## Acoustic Warning or message occurring when a closed sliding door is not recognized

Topic number	LI80.20-N-079697
Version	1
Function group	80.20 - Central locking system, interior central locking
Date	6/8/26
Validity	Model series 447, 907  without SA code T55/T50/EL9 electric operation for right sliding door  without SA code T56/T51/EL9 electric operation for left sliding door
Reason for change

Attachments	
File	Description
447_907_910_Bilder_Türkontakt.png 	Damaged door contacts caused by corrosion/vibration

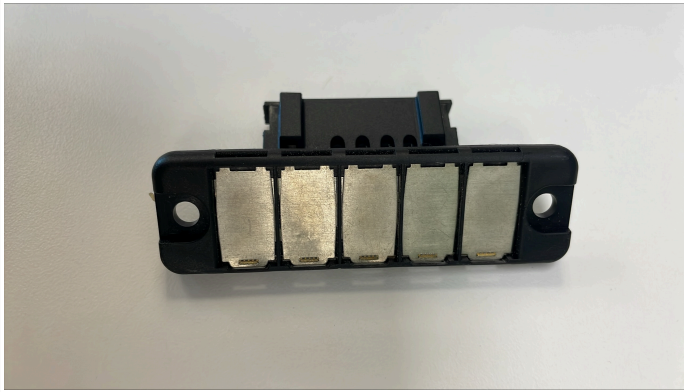
Customer may state the warning message or indicator accompanied by acoustic tone alerting the sliding door is ajar when the door is completely closed

- Mechanical damage through bending when loading and unloading
- Worn contact plates --> After detachment of silver plating, the copper plate is corroded
- Movement of sliding door/body when driving --> Contact pins do not always make contact with contact plate --> Central locking system fault message in instrument cluster

In a problem case, replace contact switch for vehicles with +T50/+T55/+EL9 or contact plate with A4478201903.
